Carbon-Free by 2050

Pathways to Achieving North Carolina's Power-Sector Carbon Requirements at Least Cost to Ratepayers

Prepared for North Carolina Sustainable Energy Association, Southern Alliance for Clean Energy, Natural Resources Defense Council, and the Sierra Club

July 20, 2022

Figure 11. Capacity Expansion “Typical Day” Load Shape, Example

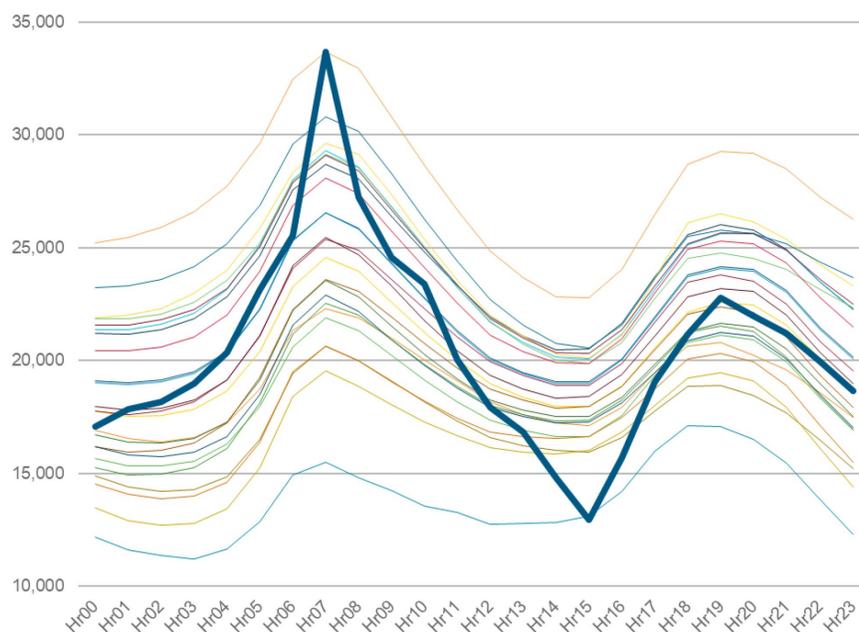
Duke Energy's justification for the manual replacement of battery storage selected by EnCompass with gas CT capacity is that the "typical day" load construct used by EnCompass to ensure that resource portfolios can serve a wide variety of conditions favors battery storage technologies that can serve a narrow 'peak' over CTs that can provide capacity over a longer period. Figure 2 provides an example of this "typical day" load shape.

First, while it is true that the Duke Energy’s capacity expansion runs use the “Typical Day” load construct, Duke also applies additional simplifications to system load for these runs. Duke Energy’s capacity expansion runs condense each 24-hour day into six 4-hour intervals.³⁵ This interval represents the smallest unit of time available to EnCompass during one of Duke’s modeling runs: load is constant over the course of a single interval, and dispatch choices, for example, cannot change during an interval. Therefore, at a minimum, any “peak” observed in the capacity expansion would need to be at least four hours in duration. Given this additional transformation, “Typical Day” daily peak loads are not, in fact, modeled as “needle peaks.”

Second, Duke Energy’s proposed remedy to this solution contemplates substituting only one resource type—gas-fired CTs—for one other resource type—battery storage. This approach runs directly counter to the resource planning principle of allowing all resources to compete and choosing the most economical portfolio. Solar generation, for example, would generate a substantial portion of its energy between Hour 9 and Hour 15 on Figure 11. Some combination of solar and other resources, including longer-duration storage, might have even more cost-effectively addressed load, but Duke Energy did not consider other configurations of resources beyond additional CTs. Duke Energy did not provide the PVRR value of this replacement in their proposed Carbon Plan, nor did it cite any specific reliability standard in justifying these replacements.³⁶

Figure 12. Manual Changes to Duke Energy Portfolios through 2035 and 2050, Duke Energy Portfolio 1

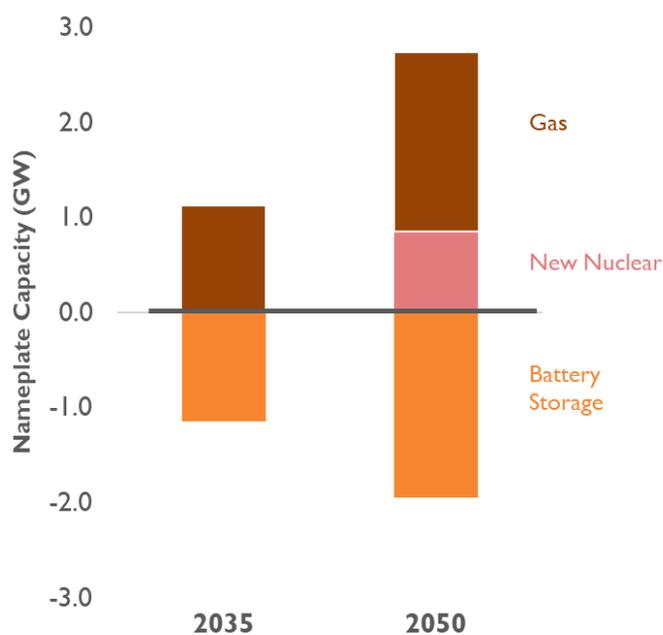
Duke’s manual revisions had a sizable impact on the system capacity mix for Duke Energy’s portfolios. Figure 12 below shows the cumulative impact of manual revisions on Portfolio 1.

For context, the total nameplate capacity of Duke Energy's generation fleet across all resources today is roughly 40 GW; the 5 GW net change in 2050 represents roughly one eighth of Duke Energy's total nameplate capacity today. This represents a substantial deviation from the portfolio selected by EnCompass's economic optimization software. As stated above, these resources were not subject to the declining HB 951 carbon mass cap that guided EnCompass resource selection in Duke Energy's initial cost runs. Given that Duke Energy adds gas and removes energy storage in the first half of the planning period, this might help to explain why some of Duke Energy's portfolios fail to meet carbon reduction requirements by their intended dates.⁴⁴
